Generic Request for Order EA-03-009

**SUBJECT:** Generic Request for Order EA-03-009

**Supplement to MRP-95 Addressing Action Items from 10/09/03  
Teleconference with NRC**

**Peter C. Riccardella  
Structural Integrity Associates  
Oct. 10, 2003**

**Figure 1 – Expanded Plot of Hoop Stresses in Region below 13° Nozzle in Plant B Showing Semi-Elliptical Surface Flaw Assumption**

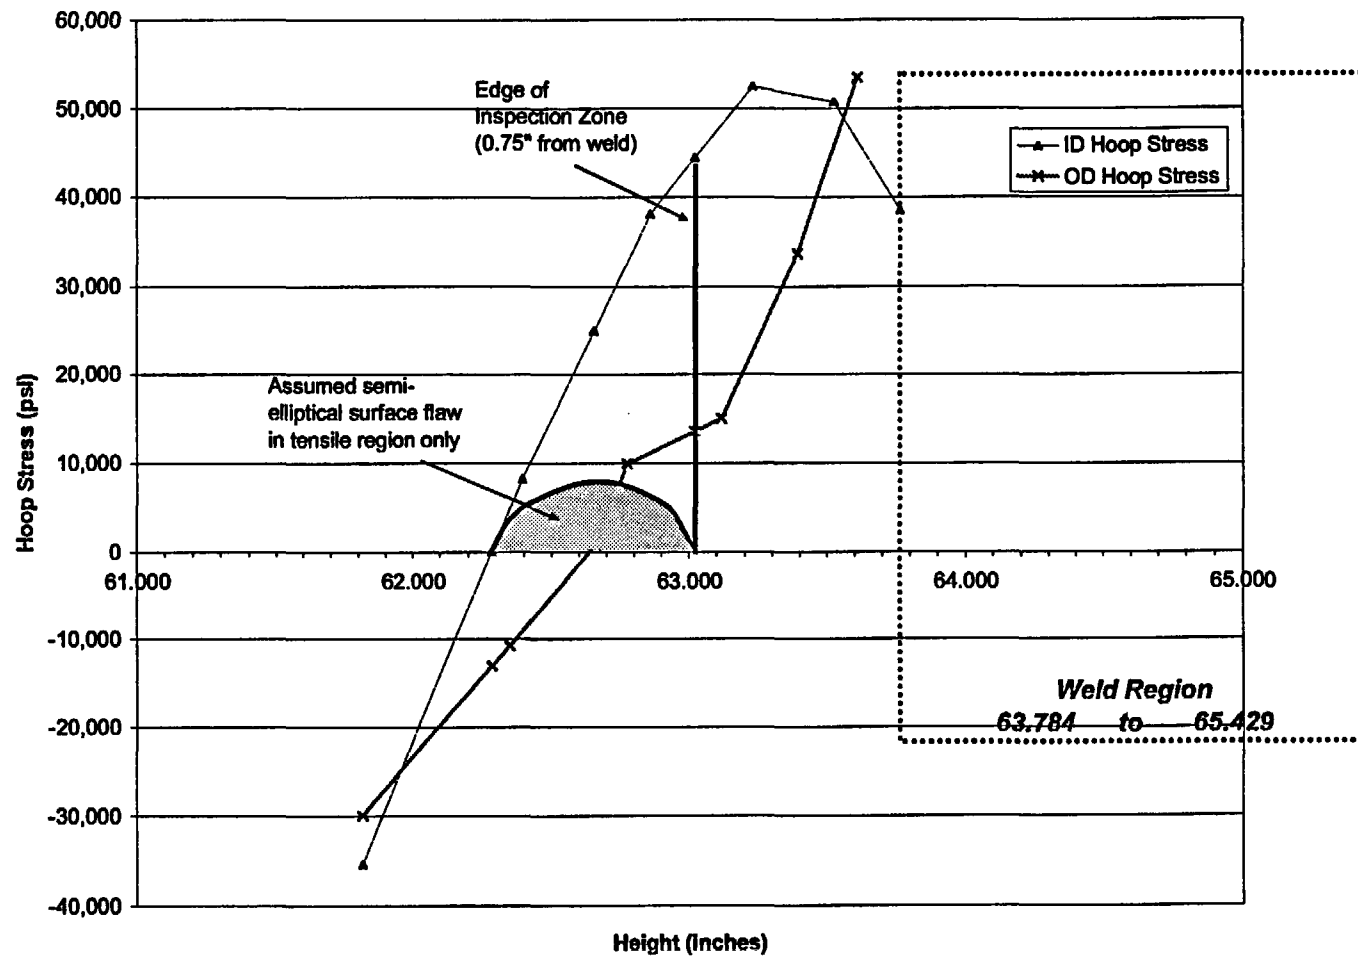
**4. Evaluation of semi-elliptical surface flaw in tensile region below weld of worst-case nozzle.**

A semi-elliptical, ID surface flaw was assumed to be present at the limiting, downhill location of the above-noted worst case nozzle (Plant B 13°). An expanded plot of the hoop stresses in that region is provided in the attached Figure 1. The assumed semi-elliptical surface flaw is also superimposed on that plot. The surface flaw was assumed to extend from the point at which the ID hoop stresses become positive to the edge of the inspection zone (0.75" below the weld). This results in a flaw length of 0.75" at the

surface. A flaw aspect ratio of 0.5 was assumed, which yields a maximum depth of 0.375", more than half the tube wall thickness. The mid-plane ID surface stresses were assumed to be acting on the flaw, which yields a K at the flaw tip impinging on the inspection zone of 22.0 ksi $\sqrt{\text{in}}$ , which is considerably less than the stress intensity factor reported in the revised Table 4.3 for a through-wall crack impinging on the inspection zone (36.6 ksi $\sqrt{\text{in}}$ ). Even if the stress at the edge of the inspection zone 44 ksi ID to 14 ksi OD is assumed to be acting over the entire flaw (a very conservative assumption), the resulting stress intensity factor is 36.1 ksi $\sqrt{\text{in}}$  which is still smaller than the through-wall crack value. Thus it is demonstrated that the through-wall crack assumptions used in MRP-95 (from the bottom of the tube to the edge of the inspection zone) conservatively bound the crack growth rates that would be predicted for smaller surface flaws in the tensile region, for the worst case nozzle and flaw location.
